12/2012 Product News

3. New VS Player Windows V6.1.1_2 resolved error issue

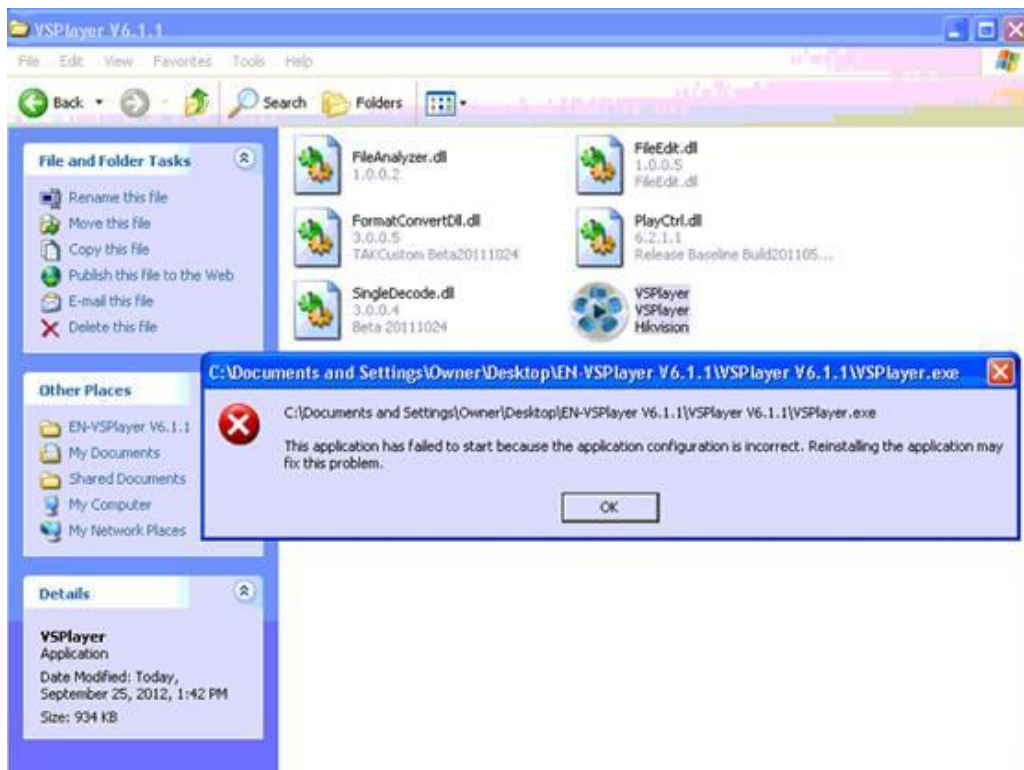
Error message when running VS Player V6.1.1.1 On XP, windows server and Win 7.

The HDD cables in the standard chassis DVRs are coming loose during shipping

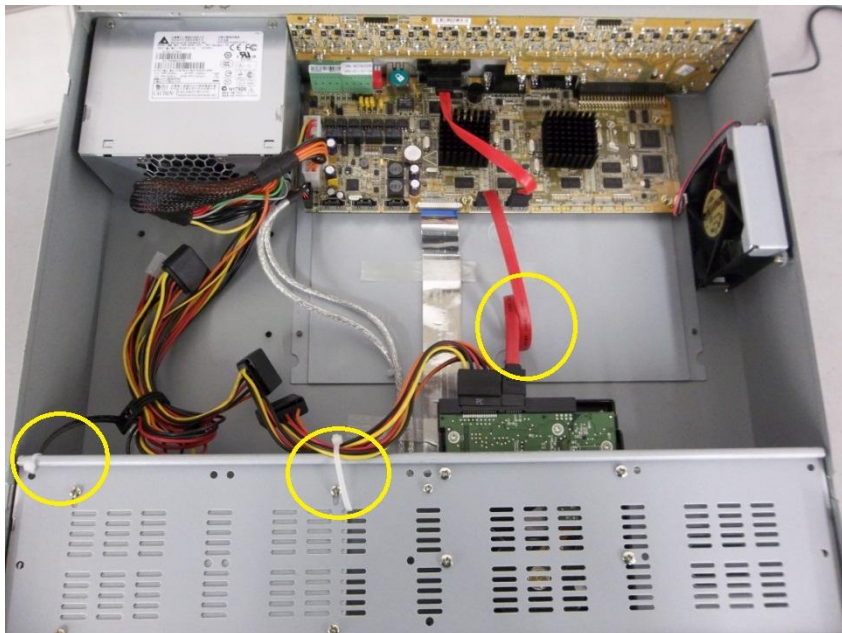
Per the advice from our HDD Rep, we have added a "Service Loop" to the SATA cable. We have also used additional zip-ties to secure the SATA power cords to the HDD bays to limit movement during shipping. See picture bellow.
